ADDENDUM # 2

Bid 21C5, Lincoln A Facility Roof Replacement Project

**FREDERICK COUNTY PUBLIC SCHOOLS
LINCOLN 'A' FACILITY
ROOF REPLACEMENT**

ADDENDUM NO. 2
January 29, 2021

ROOF PLAN

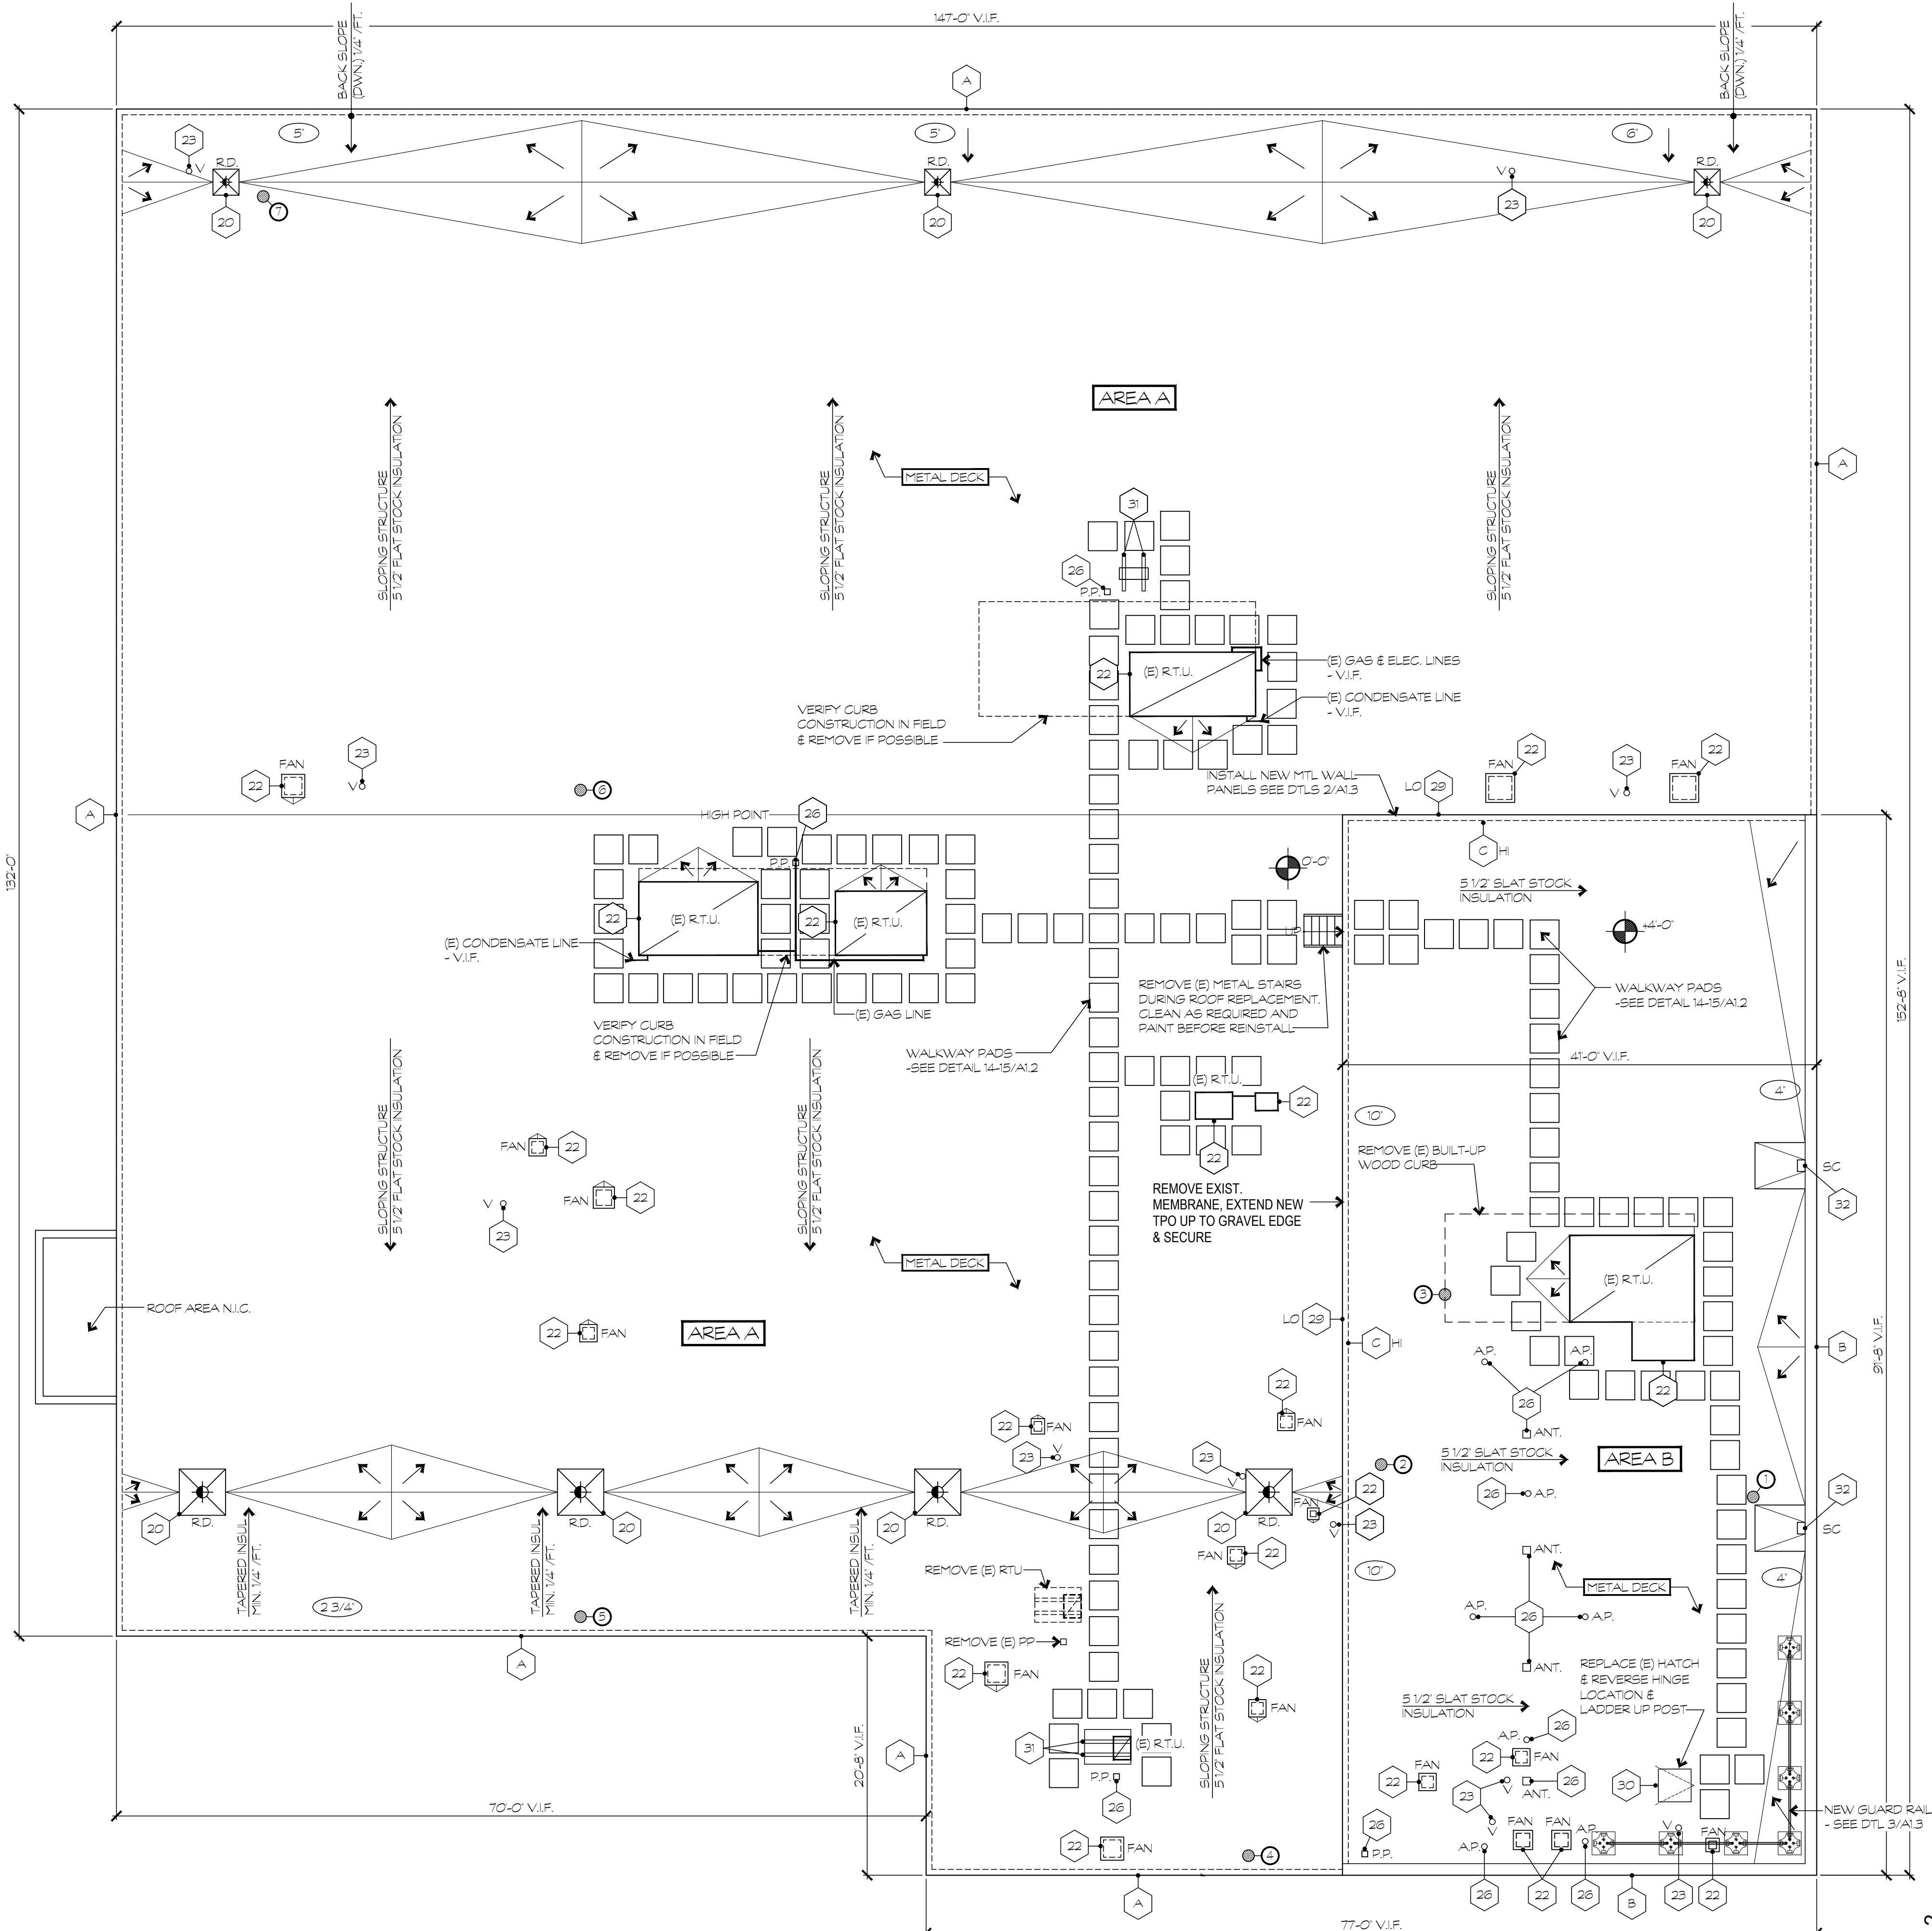
- ITEM NO. 2.01 Metal panels are not required. Disregard the note to replace metal fascia panels around the front perimeter and at the change in height at area A to B. Therefore, no metal panel specification will be issued.
- ITEM NO. 2.02 At transition of roof elevation at Area A and B, the exposed wall shall be covered with adhered TPO membrane, provide batten strips as required.
